DEPARTMENT OF WATER RESOURCES

RE: Application for Transfer 790054

The Department has received an application for transfer from William and Barbara Slavin (enclosed). The transfer proposes to move the Point of Diversion for the Slavin's Water Rights downstream, near the confluence of Carmen Creek and the Salmon River.

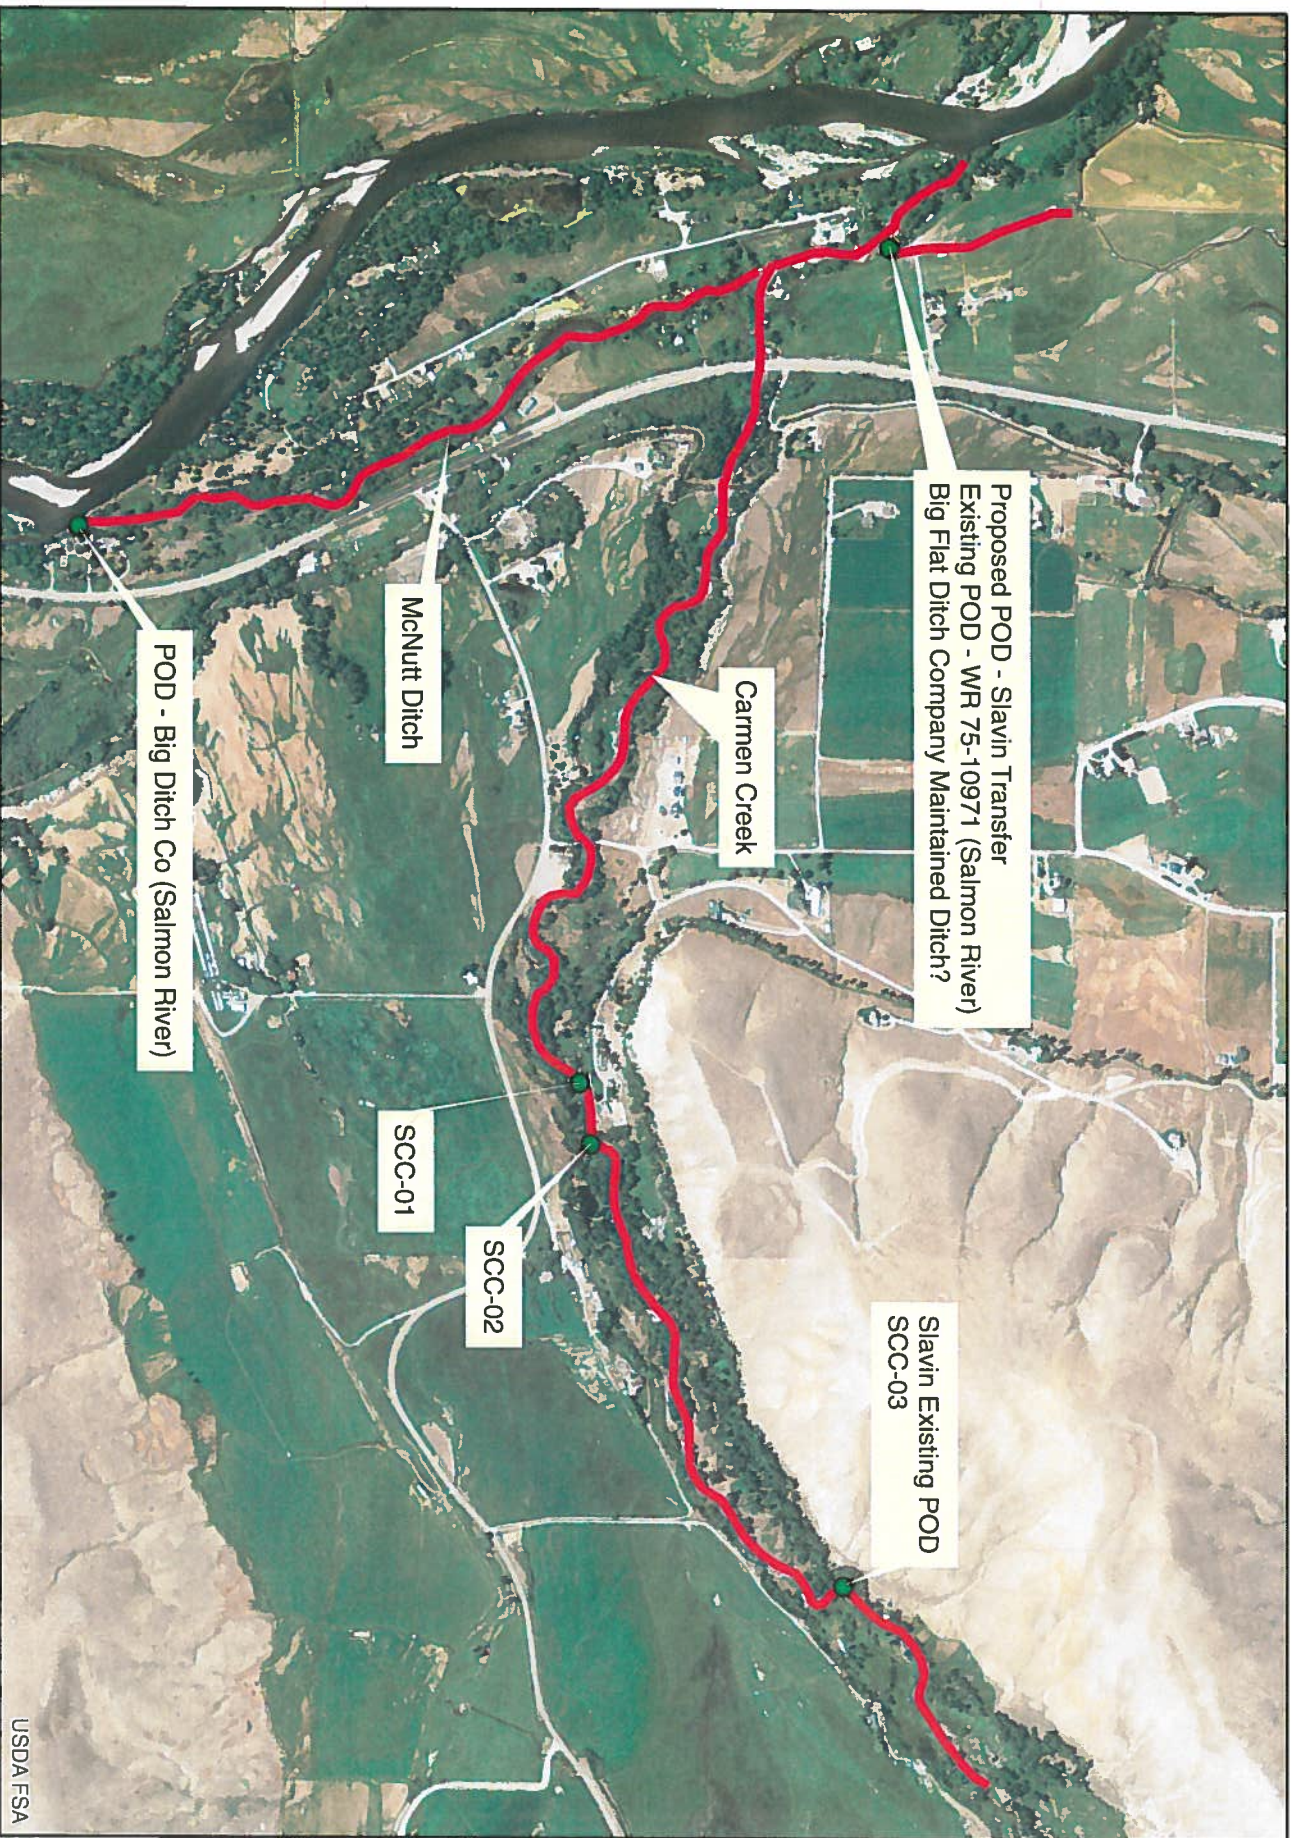
In order to fully consider this application, further information regarding the system is necessary. Would you please take a moment to review the enclosed application, and map of the area?

In August of 2013, Department representatives were at the location and completed measurements between the Slavin's existing diversion on SCC-03 and the downstream SCC-02 diversion. However, these measurements did not continue past SCC-02. This lack of measurement has left several questions unanswered. Will water not diverted at SCC-03 actually make it downstream to the proposed new point of diversion? Will this excess water be diverted at SCC-02 and SCC-01? Is it possible for the watermaster to regulate the water in such a manner to get the water downstream?

Figure 1. Schematic of lower Carmen Creek from SCC-03 to below SCC-01 showing measurements and observations of stream flow and diversions on August 29, 2013.

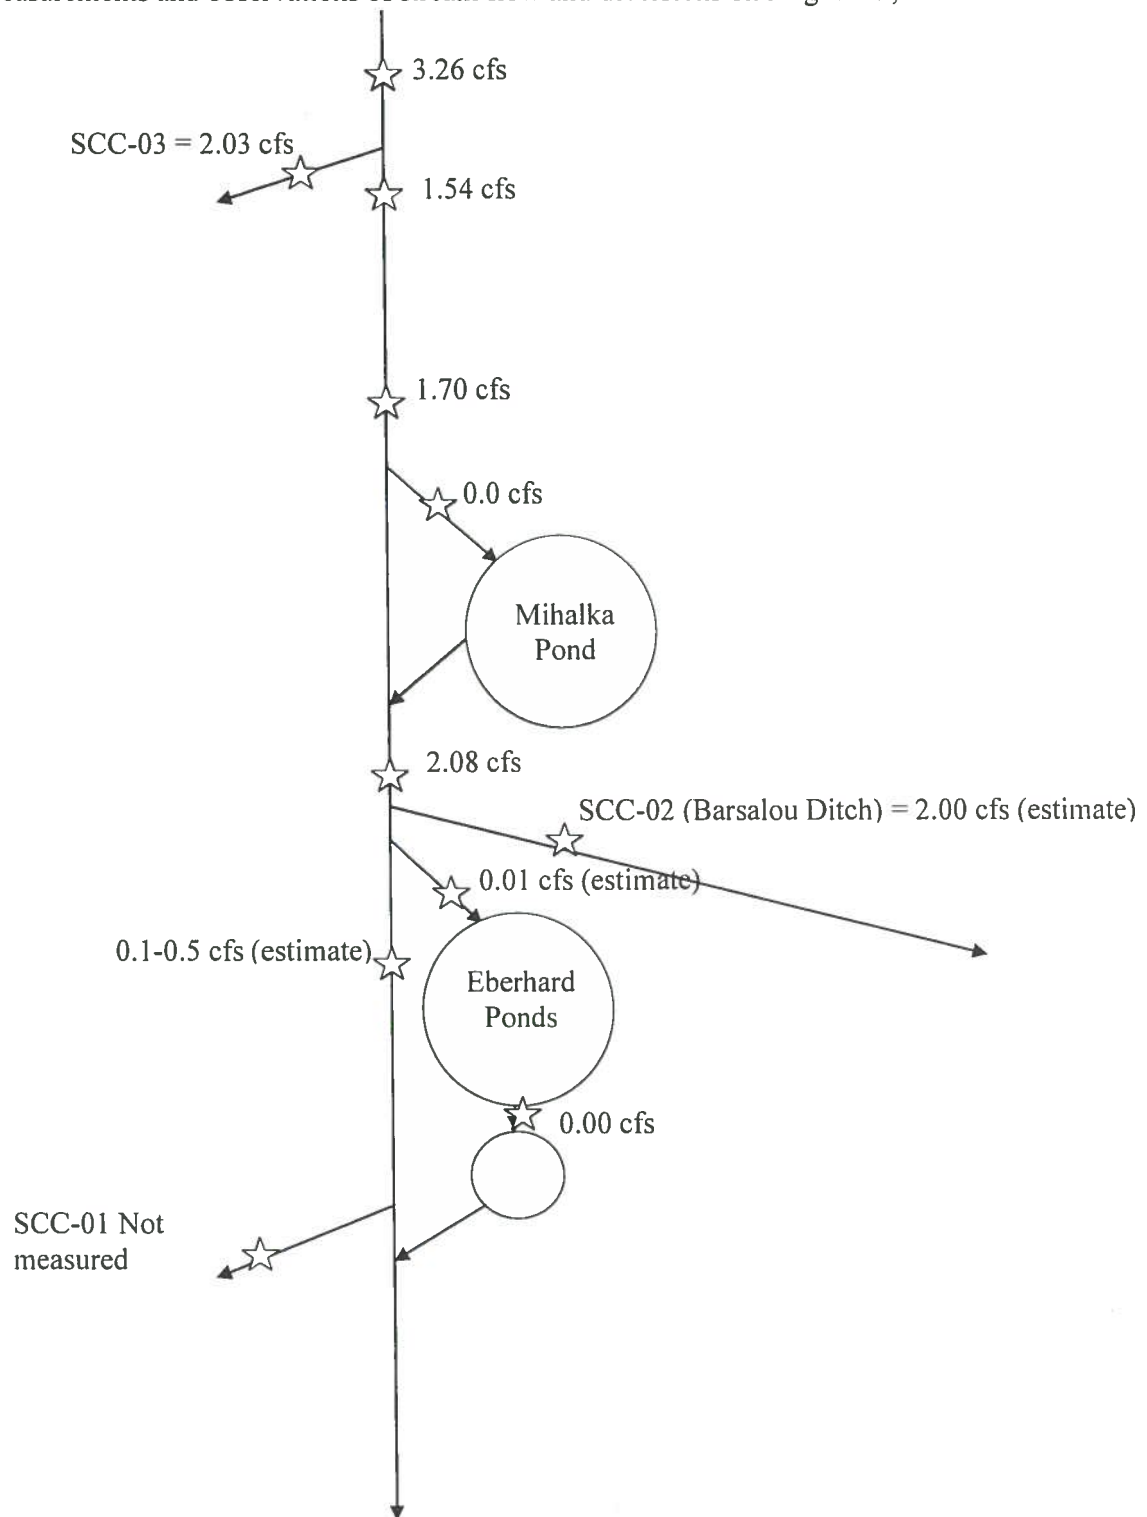
I found that any losses to seepage through that reach appear to have been offset by gains from springs and seeps that entered the stream at various points in the reach. Further, it appears the injection of the water that would otherwise have been diverted at SCC-03 resulted in a live stream of water between SCC-03 and SCC-02 where the stream was mostly dry before the injection.

In conclusion, it appears that the proposal to transfer water from SCC-03 to the McNutt Ditch will result in a live stream between SCC-03 and SCC-02.
